**Subject: Draft Corrective Action Report for Groundwater**

**Facility:** Al Phillips the Cleaner (former)  
3661 S. Maryland Parkway  
Las Vegas, Nevada  
Facility ID: **H-000086**

### DRAFT CORRECTIVE ACTION REPORT FOR GROUNDWATER

NDEP Review Comments, July 12, 2013

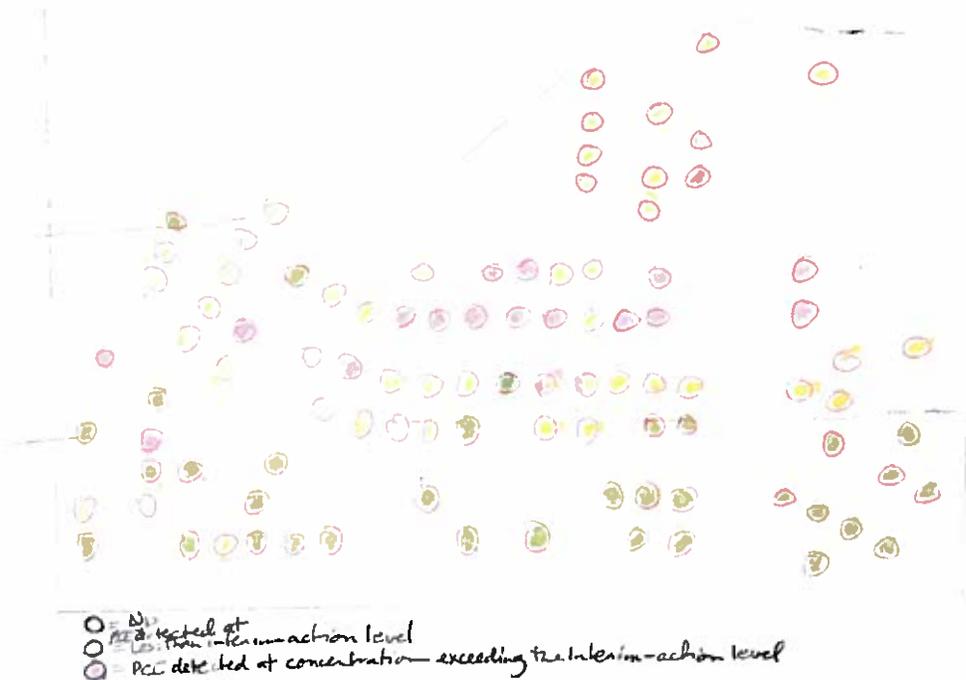
28. Appendix F, Section 1, Introduction, paragraphs 1 and 2 contain text that the NDEP previously marked for revision in the preliminary draft HHRA. Please go back to those comments and red-lined text and revise this section accordingly. The discussions of liability and who owned what when are not relevant to the risk assessment.

*The Maryland Square Tetrachloroethene (PCE) Site is east of downtown Las Vegas, Nevada. Shallow groundwater at the Site contains a PCE plume that extends from the location of the former dry cleaners (Al Phillips the Cleaners), in the former Maryland Square Shopping Center (Figure 1), to approximately 6,000 feet east (downgradient), just east of Eastern Avenue (Figure 2). This plume of PCE-contaminated groundwater extends beneath the Paradise Palms residential neighborhood, more than 1,000 feet downgradient from the source area (Figure 2).*
